# Modification Recommended Service Note

## P9372B Keysight Streamline Vector Network Analyzer

Serial Numbers: From MY61100288 to MY61100353

Potential lifted front panel overlay

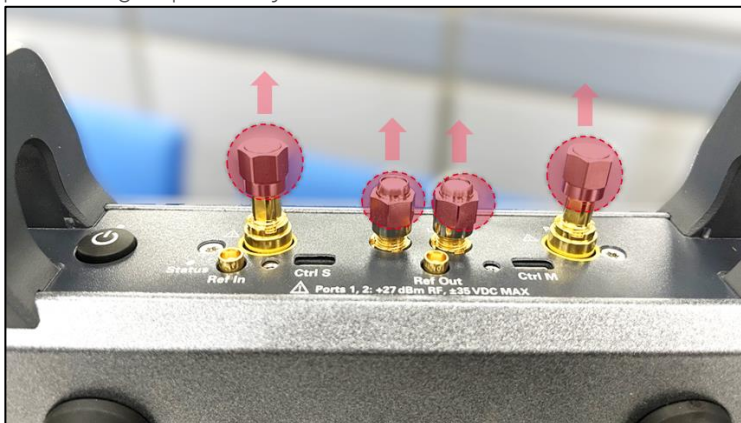
Keysight streamline series vector network analyzer (VNA) of serial number range identified in service note cover page might potentially exhibit the following lifted front panel overlay symptom.

Apart from cosmetic imperfections, the lifted front overlay could have led to non-fully attached *Ctrl S* micro-HDMI cable connector in multi-VNAs setup configuration.

-> Apply this service note only if end users' VNA is exhibiting the following symptom.

Procedure to replace the front panel overlay.

1. Remove the front handles. Detach the 50-ohm termination (LO-In, LO-Out, Port 1 & Port 2) or protecting caps if they are attached to the VNA.

2. Pry open the existing front panel overlay and remove it from front panel.
3. Clean the metal surface thoroughly and ensure it is free of adhesive residue.
4. Affix the new self-adhesive front panel overlay onto the metal surface.
5. Reinstall (reuse) the 50-ohm terminations and port protecting caps accordingly.

6. Reinstall (reuse) the front handles.
